JEFFERSON COUNTY
PLEASURE ISLAND SHORE PROTECTION
REVISED BREAKWATER-MARSH RESTORATION PROJECT

Addendum No. 2
Questions and Answers
March 15, 2013

Geotechnical Information

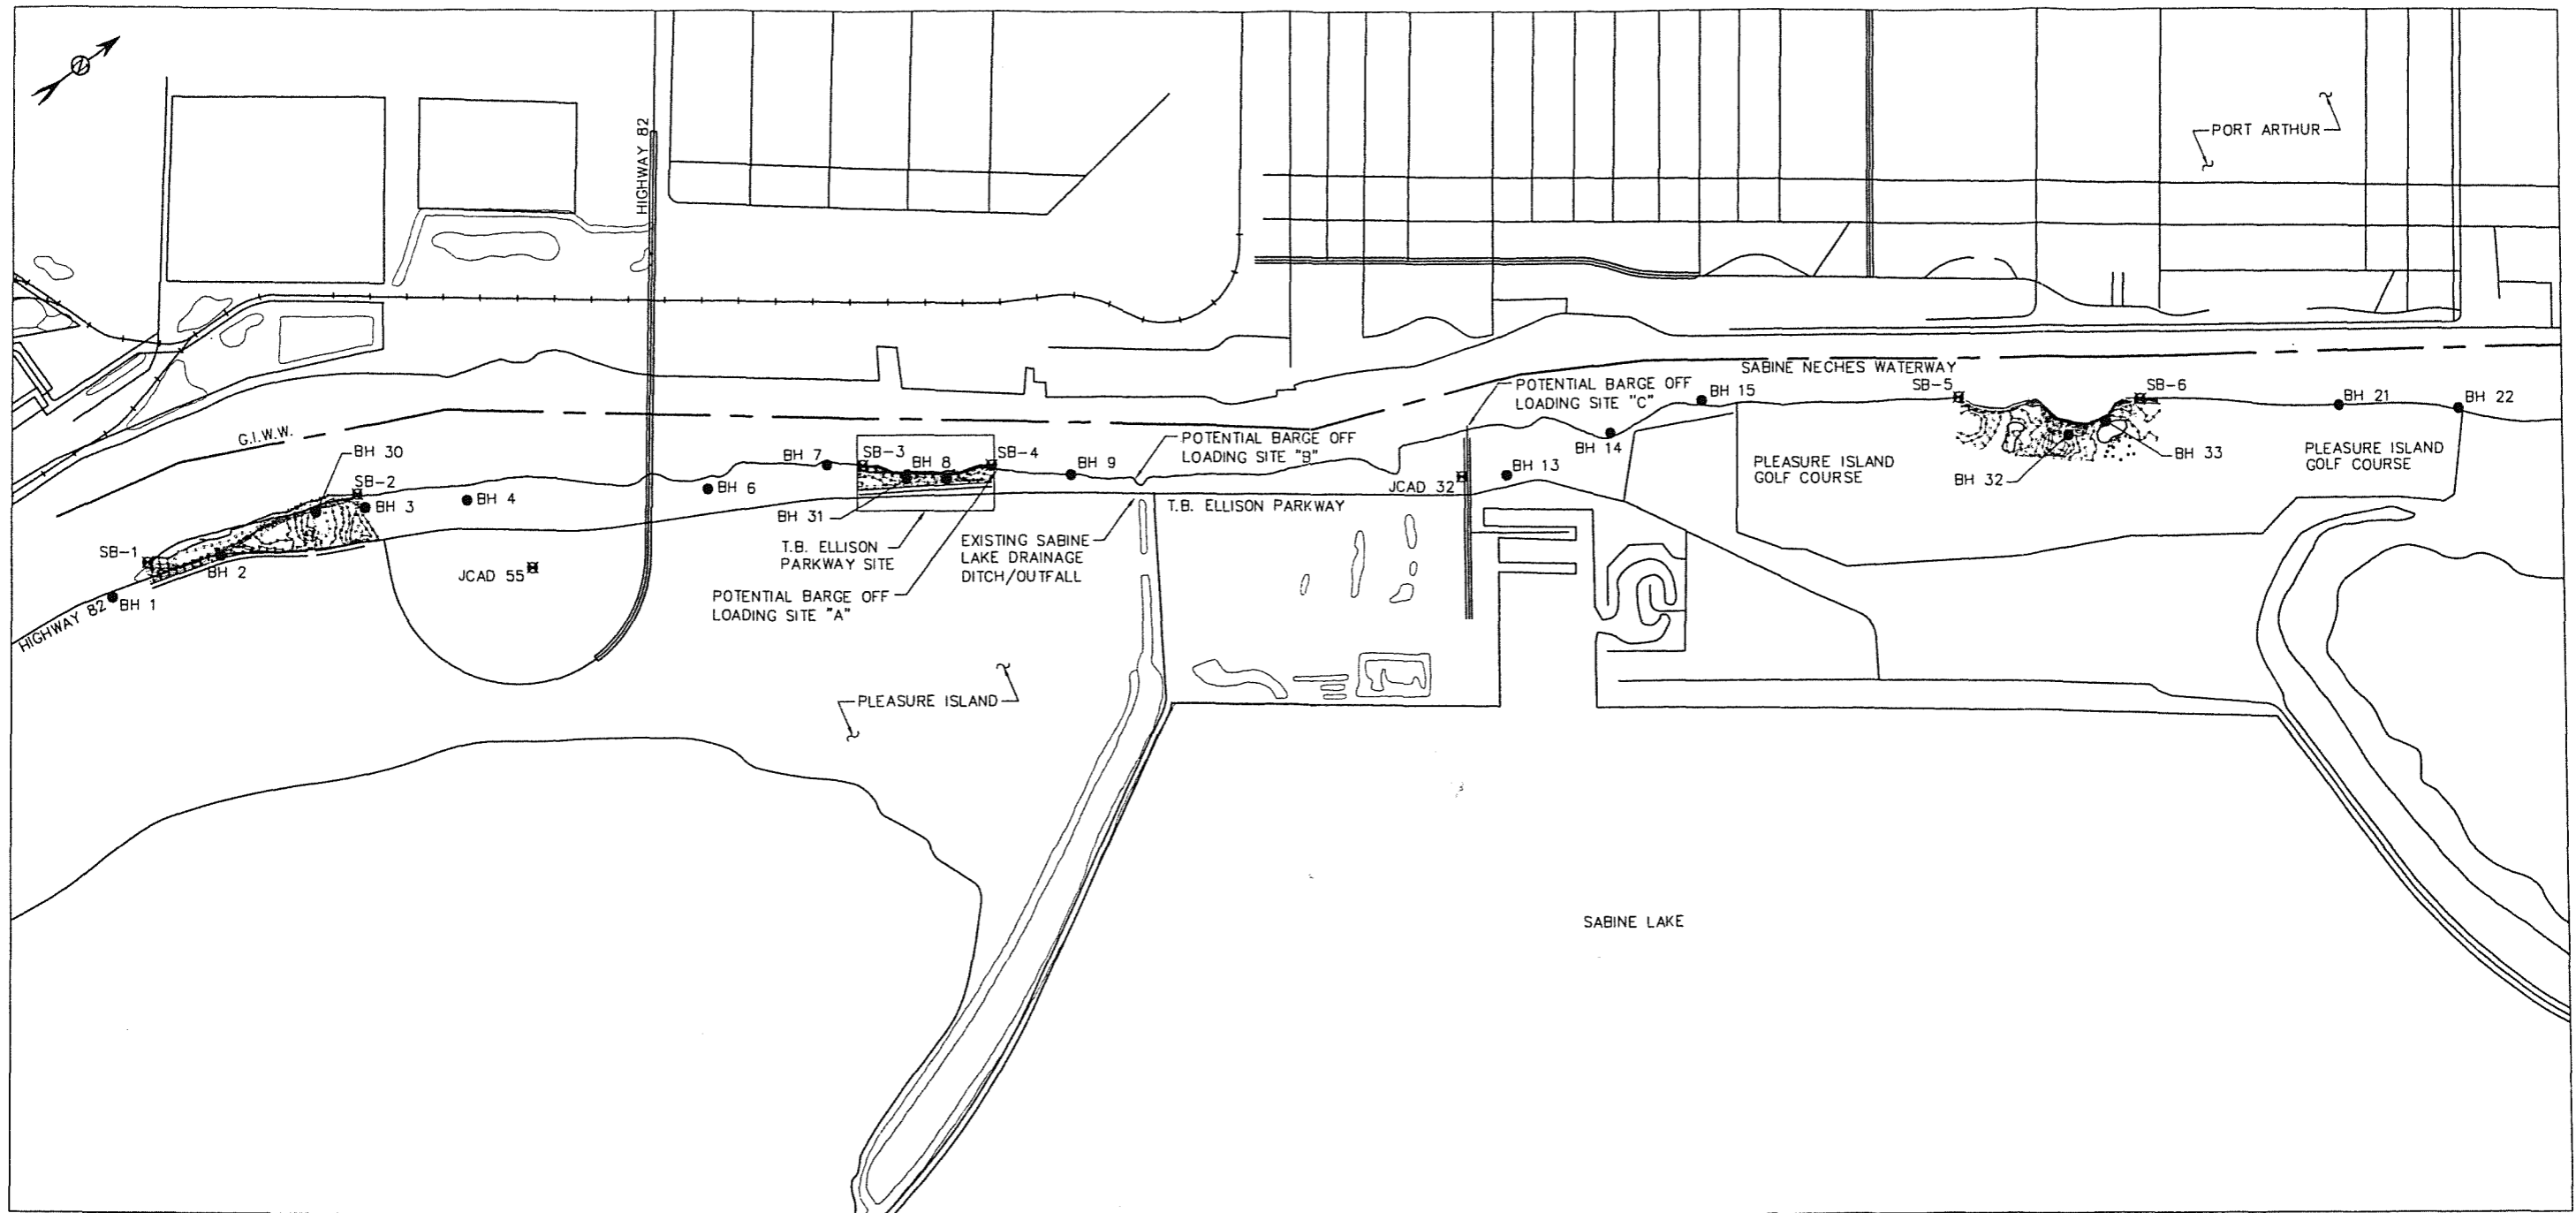
21. **Question:** Please provide all geotechnical data associated with the construction area including a map or coordinates of the boring locations.

Response: See “Exhibit A”.
